Primary Or Secondary?

The Glitch

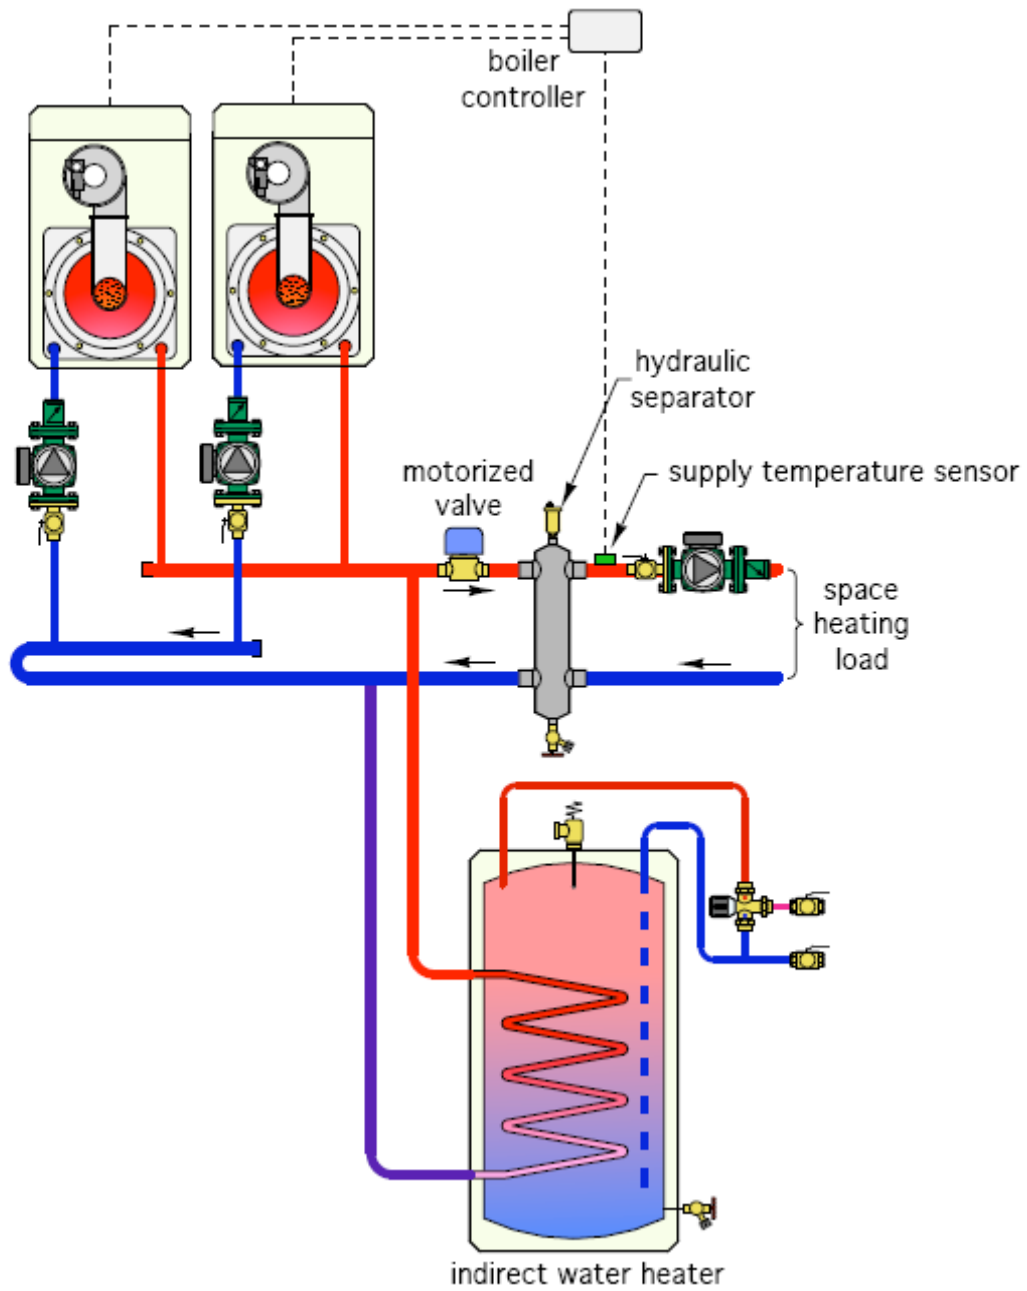
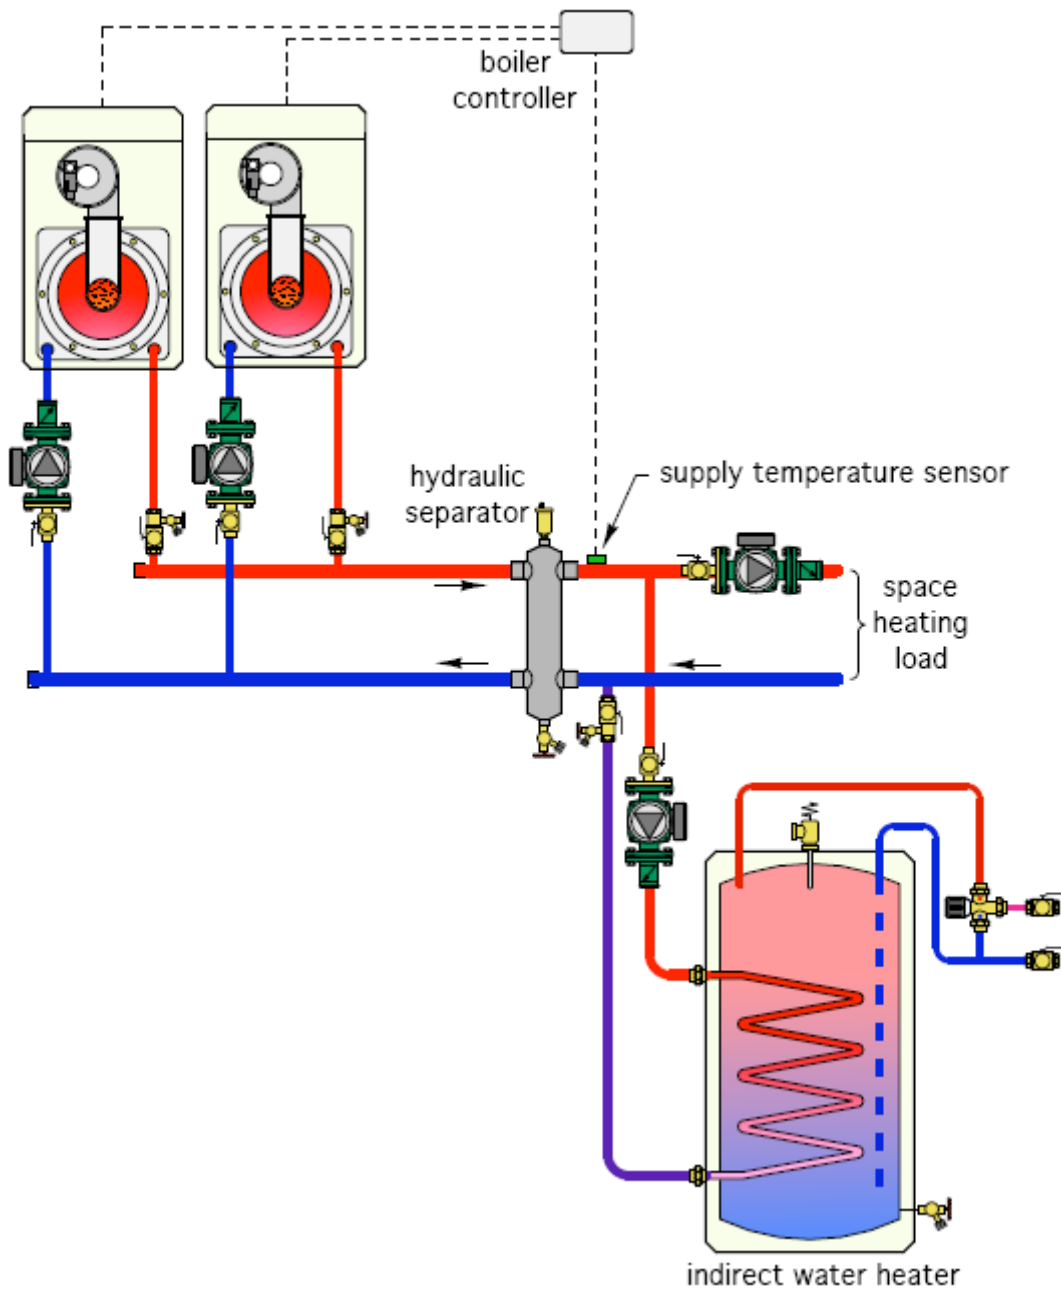
Overview: A designer needs to connect an indirect water heater to a multiple-boiler system. He selects a hydraulic separator for the project and connects the piping of the indirect water heater on the same side as the boilers. He also specifies a motorized valve as shown in the schematic. This valve will close during the domestic water heating cycle so that one or both of the boiler circulators can drive flow through the indirect water heater.

One problem with the original design is that the supply temperature sensor for the multiple boiler controller is installed on the outlet side of the hydraulic separator. Most boiler controllers only have a single supply temperature sensor that has to provide feedback to the controller in both the space heating and domestic water heating modes. The sensor cannot provide accurate feedback without flow passing through the piping to which it is attached (as would be the case with the original design).

The cost of a large motorized valve is probably as much if not more than a separate circulator for the indirect water heater. The latter also ensures good flow through the tank's heat exchanger regardless of flow through the boiler(s).

Maintaining flow through the hydraulic separator in both operating modes also allows the air and dirt separating functions of the hydraulic separator to remain in effect. Heat loss from the hydraulic separator is reduced during both operating modes by its insulating shell û this shell is an absolute must for any hydraulic separator.

The reverse return piping on the boilers, while not necessarily an error, is usually not necessary provided the header is sized for a very low pressure drop. This is almost always the case when the parallel piping paths connected to the headers each contains a circulator.

Finally, purging valves, an expansion tank, and a make-up water assembly have been added to the sub-circuits in the fix drawing.
